# Grimes Planning and Zoning Commission

## **Planning and Zoning Commission September 22, 2022 In Person at Grimes Community Complex, 410 SE Main Street, Room 202**

TO: Planning and Zoning Commission  
FROM: Molly Mannel, Assistant Planner  
DATE: September 6, 2022  
RE: Rock Creek Plat 1 – Preliminary Plat

TO: Planning and Zoning Commission  
FROM: Molly Mannel, Assistant Planner  
DATE: September 6, 2022  
RE: Rock Creek Building 1 – Site Plan

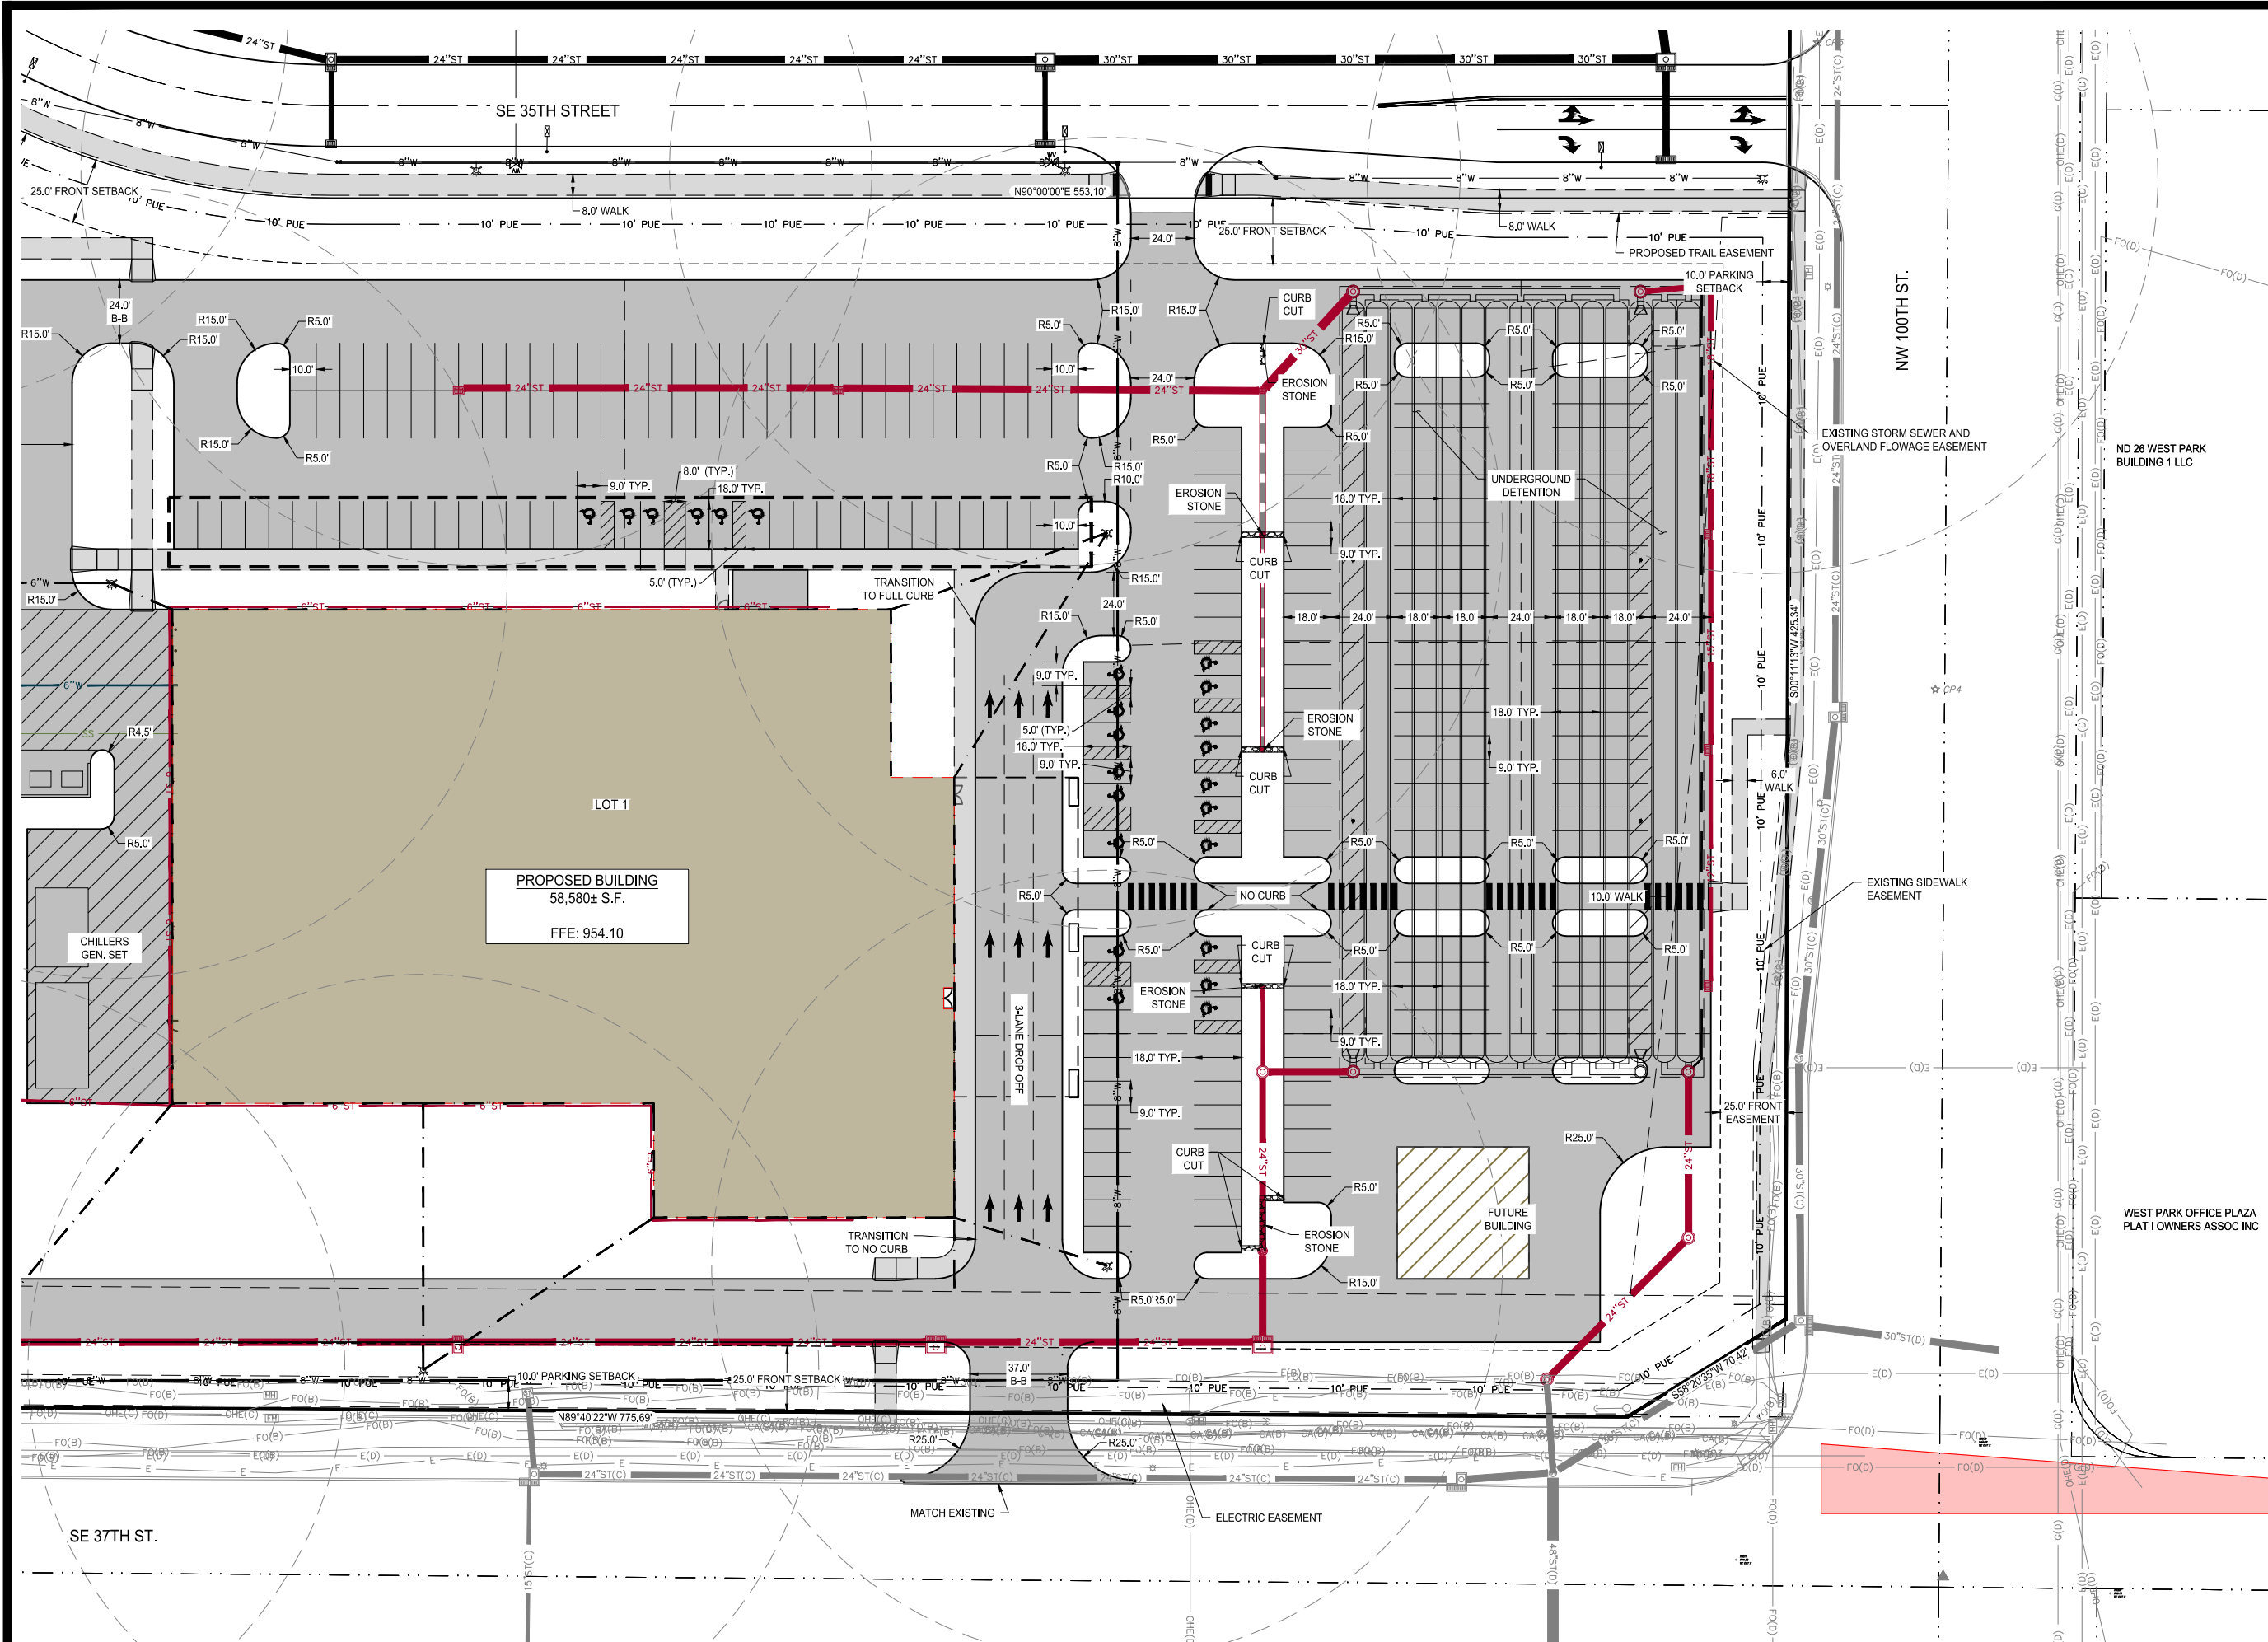
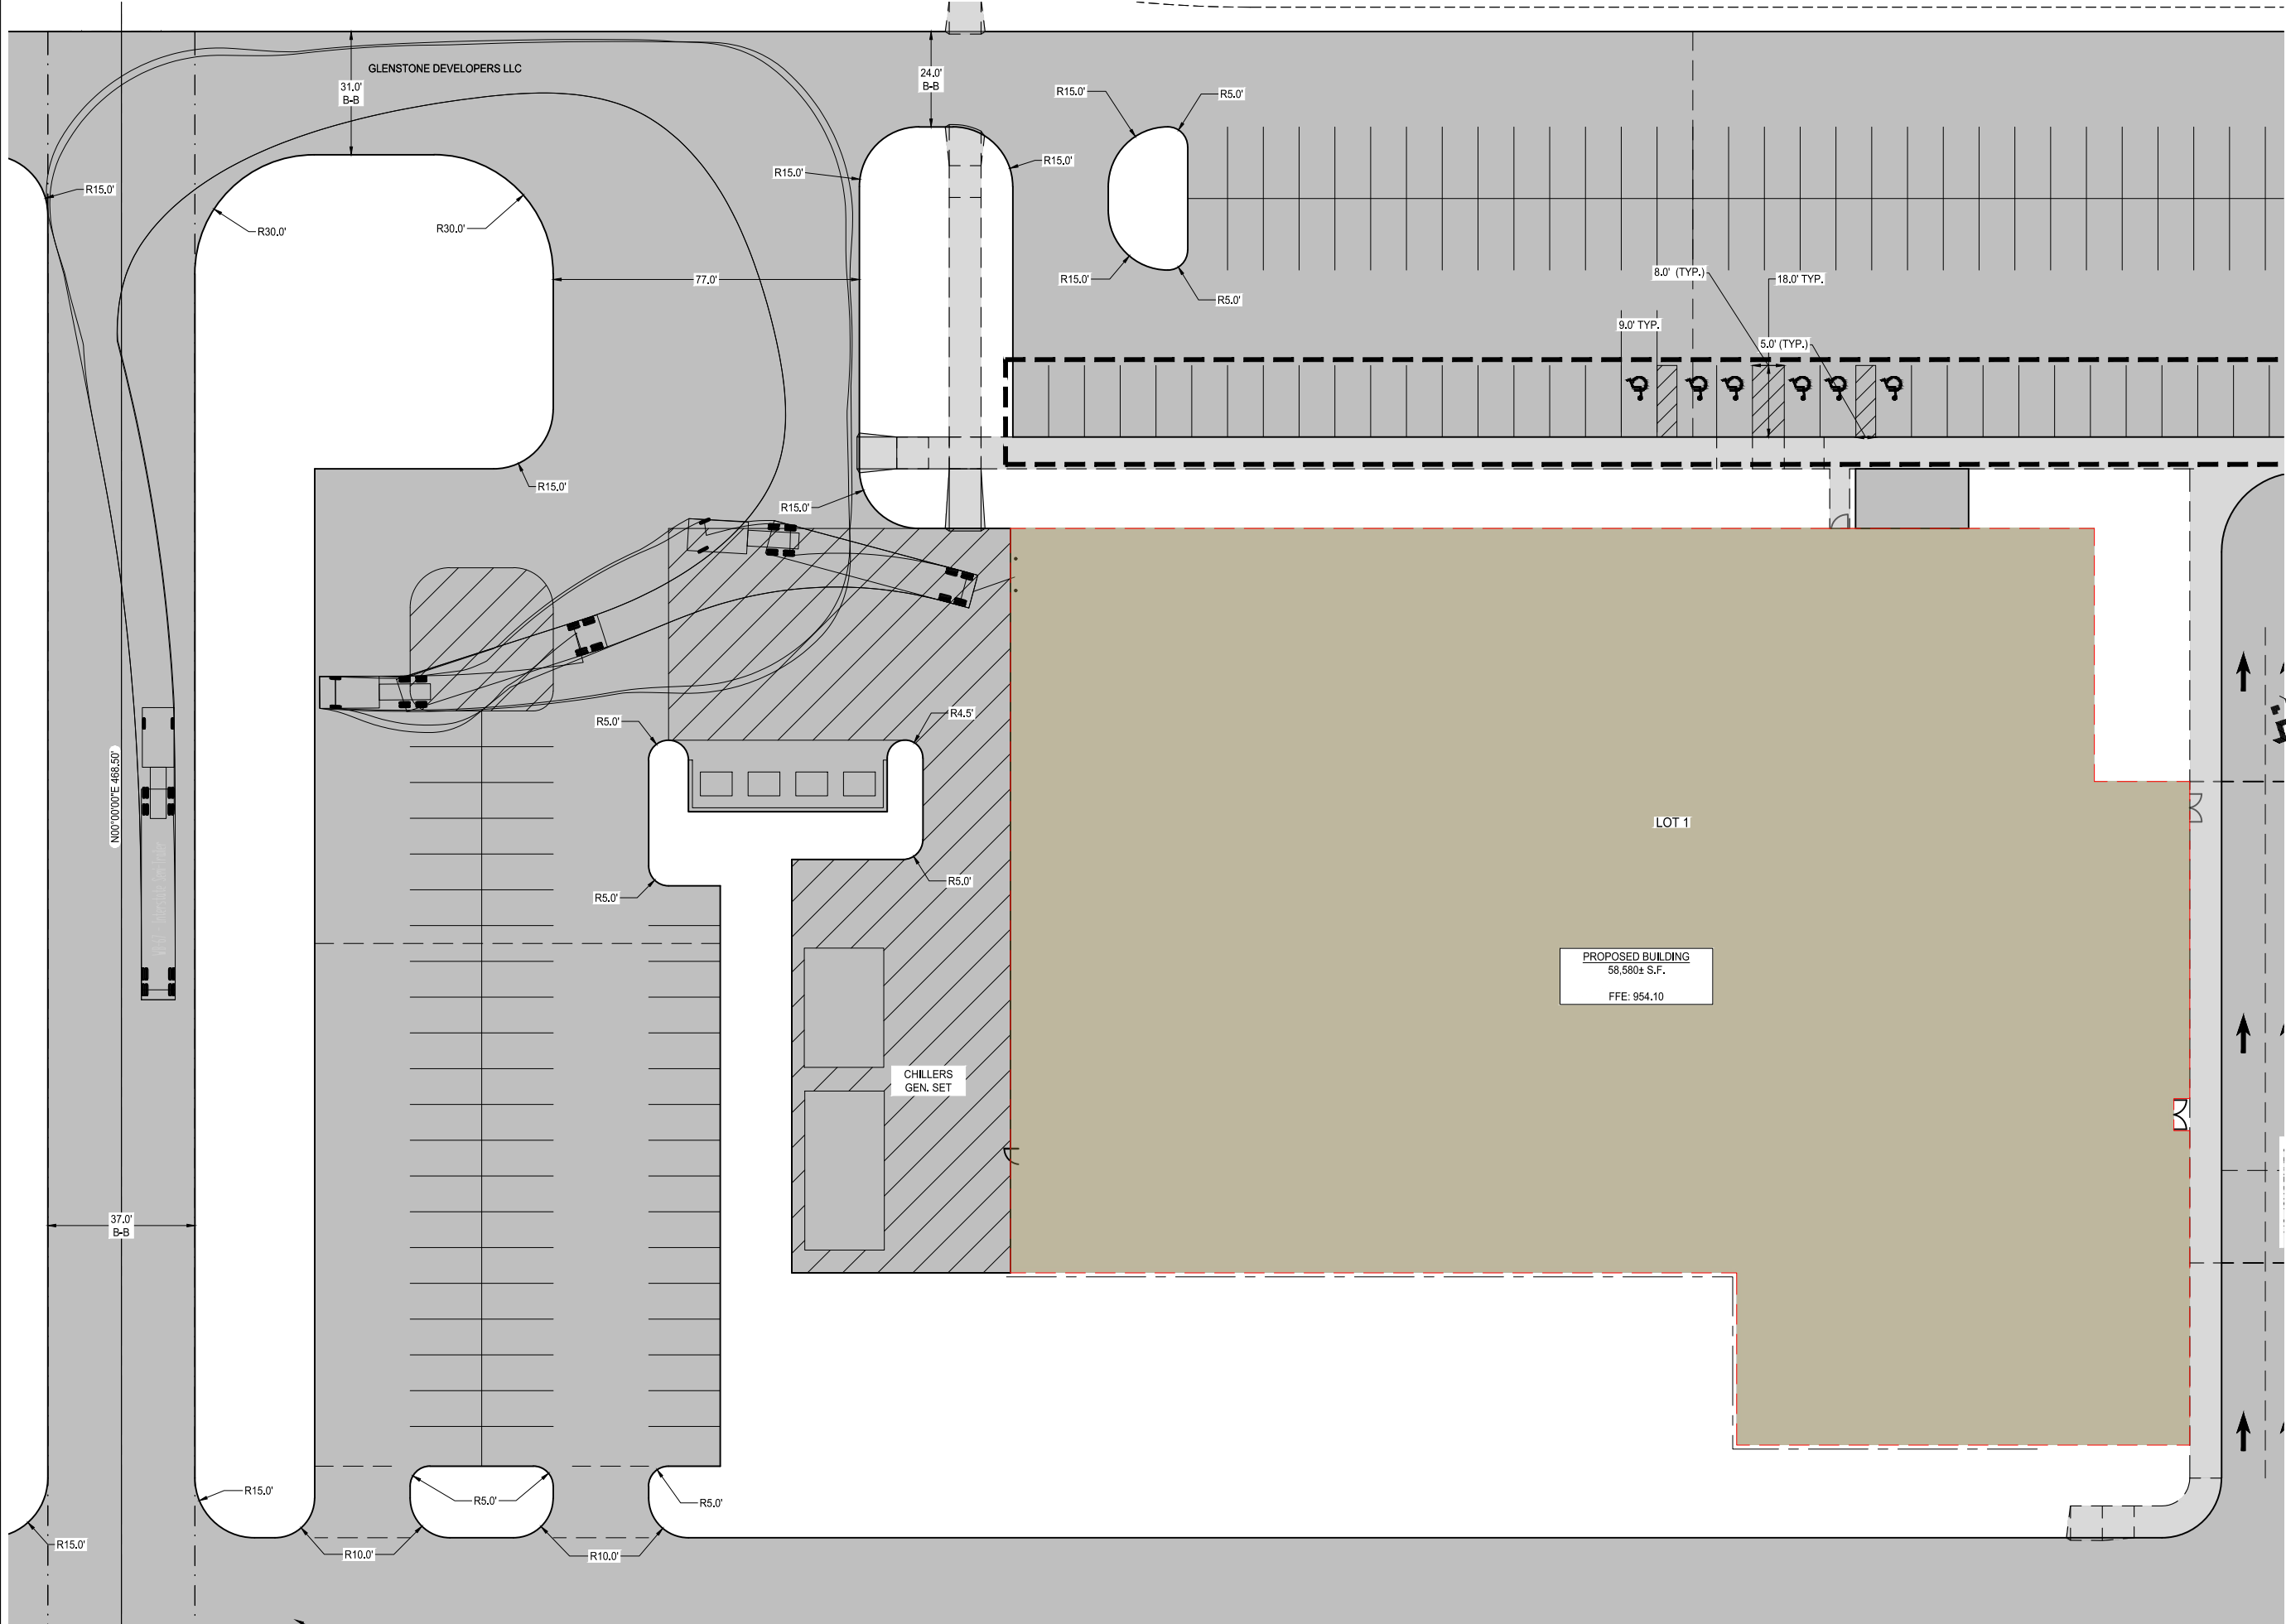
- ~~1. Provided dimensions for the ADA stalls and access aisles. Add labels to east parking lot and revise labels on the north parking lot.~~
2. Show ADA signage on sheet and label. ADA signs not shown. Please revise. Please show ADA signage for northern and southern stalls.
3. Show proper signage and arrows for the 3-lane drop-off. Not shown. Please revise. Are cars able to come in from the North/SE 35<sup>th</sup> Street and drop off? If not, please include a "DO NOT ENTER" signage.
- ~~4. Please move 3 ADA spots on the other side of the north entrance near staff patio. The ADA spots under the physician canopy need to be placed near the staff patio door.~~
